MEDLAND PROJECT
DOCKET NO 50-329, 50-330
IE BULLETIN 79-02
FILE: 0505.12 SERIAL: 7234

We have reviewed IE Bulletin 79-02 on the subject of "Pipe Support Base Plate Designs Using Concrete Expansion Anchor Bolts" against the Midland Plant Unit 1 and 2 design. Attached are three (3) copies of the results of that review.

FIGURE 1.

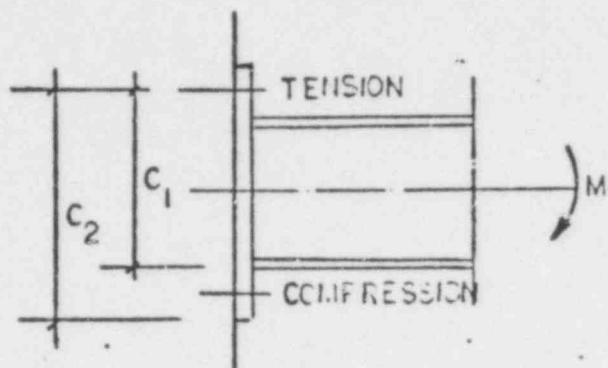
Verify that pipe support base plate flexibility was accounted for in the calculation of anchor bolt loads. In lieu of supporting analysis justifying the assumption of rigidity, the base plates should be considered flexible if the unstiffened distance between the member welded to the plate and the edge of the base plate is greater than twice the thickness of the plate. If the base plate is determined to be flexible, then recalculate the bolt loads using an appropriate analysis which will account for the effects of shear-tension interaction, minimum edge distance, and proper bolt spacing. This is to be done prior to testing of anchor bolts. These calculated bolt loads are referred to hereafter as the bolt design loads.

When the base plate is subject to a moment, the moment arm (C) to determine the tension ($T = \frac{\text{Moment}}{C}$) in the expansion anchors was taken to be equal to C_1 as shown in Figure 1. In reality, the moment arm is greater than C_1 , and will approach C_2 as the plate becomes infinitely rigid. For this project, the base plate and bolts were designed conservatively for bending loads.
